SUBJECT: THREE MILE ISLAND UNIT NO. 1 - ISSUANCE OF AMENDMENT  
(TAC NO. 75103)

AMENDMENT NO. 152 TO FACILITY OPERATING LICENSE NO. DPR-50

SAFETY EVALUATION BY THE OFFICE OF NUCLEAR REACTOR REGULATION  
RELATED TO AMENDMENT NO. 152 TO FACILITY-OPERATING LICENSE NO. DPR-50

THREE MILE ISLAND NUCLEAR STATION, UNIT NO. 1

Figure 3.5-2M

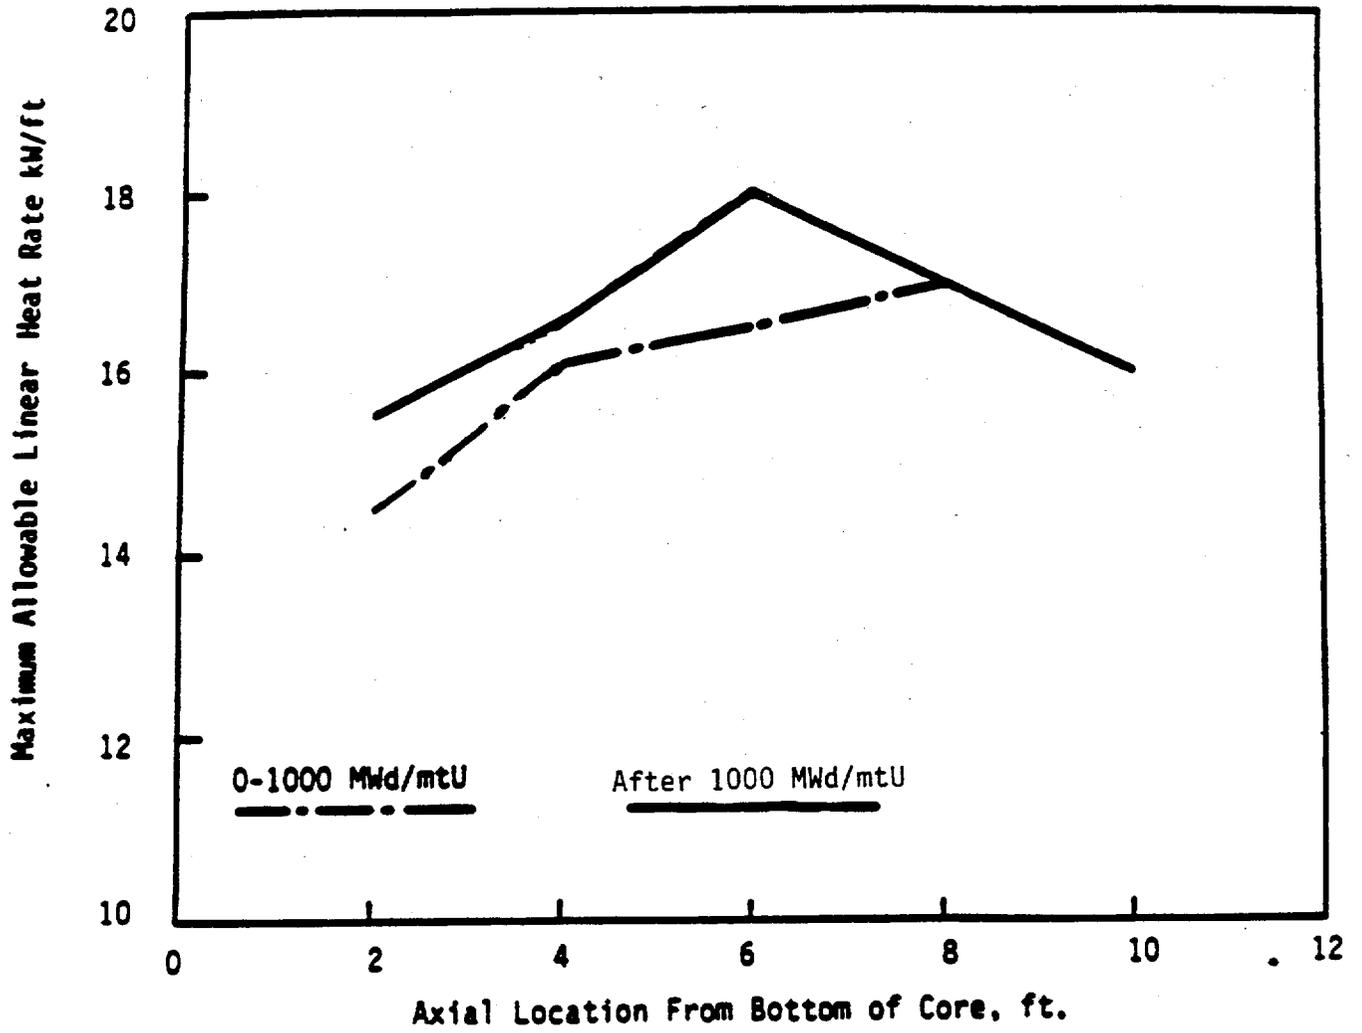
- (4) Technical Specification Figure 3.5-2M would reflect an increase in the allowable linear heat rate (LHR) limits at the 2-foot elevation from 14.0 to 14.5 kw/ft for 0 to 1000 MWD/MTU and from 15.0 to 15.5 kw/ft after 1000 MWD/MTU.

One of the proposed changes to Technical Specification Figure 3.5-2M reflects an increase in the allowable LHR limit at the 2-foot core elevation from 14.0 to 14.5 kw/ft for the burnup range between 0 to 1000 MWD/MTU. To support this proposed LHR increase, the licensee submitted the results of an ECCS analysis which was performed generically for the Babcock and Wilcox (B&W) lowered loop configuration plant with the Mark-B4 fuel rod design using the BAW-2 critical

The licensee has also proposed a further change to Figure 3.5-2M which would increase the LHR limit after 1000 MWD/MTU from 15.0 to 15.5 kw/ft. This would make the LHR limit for the 1000 to 2600 MWD/MTU burnup window identical to that for after 2600 MWD/MTU and eliminate the need for a 1000-2600 MWD/MTU window. The extrapolation of the ECCS analysis results to the next burnup window, allowing it to also be increased by 0.5 kw/ft, has been previously approved by the NRC in a letter from A. C. Thadani (USNRC) to C. N. Turk (B&W Owners Group Analysis Committee), dated October 12, 1987. Therefore, the proposed change to eliminate the 1000 to 2600 MWD/MTU burnup window and to relabel the "After 2600 MWD/MTU" window "After 1000 MWD/MTU" is acceptable.

heat flux (CHF) correlation. The analysis was performed assuming a 50 psi reduction in fuel rod pre-pressure (fill gas pressure) for the most restrictive LOCA case. This is defined as the 8.55 ft<sup>2</sup> double ended rupture at the reactor coolant pump discharge cold leg piping location with the peak power at the 2-foot core elevation (core inlet) during beginning-of-life conditions. The results of the analysis, reported in BAW-2001P, indicate that the reduced internal fuel pin pressure allows for longer burnup periods (fuel cycles) and delays cladding rupture during a LOCA. An evaluation by the licensee indicated that the 50 psi pin pre-pressure reduction would delay rupture by a time increment equal to a rise in the LHR of 0.5 kw/ft. The LOCA analysis, therefore, utilized an increased LHR of 14.5 kw/ft, as compared to the 14.0 kw/ft current generic LOCA limit, at the 2-foot core elevation for the burnup interval between 0 and 1000 MWD/MTU. The licensee used the current NRC-approved LOCA analysis computer codes for the analysis and the results were in conformance with the ECCS acceptance criteria of 10 CFR 50.46. The Mark-BZ fuel used in TMI-1 is not expected to affect the LOCA limits established for the Mark B-4 used in the analysis at the 2-foot elevation. In addition, the change in CHF correlation from the BAW-2 to the BWC correlation, used in the TMI-1 analyses, has no effect on the predicted time of DNB at the 2-foot elevation. Therefore, the proposed increase in allowable LHR from 14.0 to 14.5 kw/ft between 0 to 1000 MWD/MTU at the 2-foot elevation is acceptable.
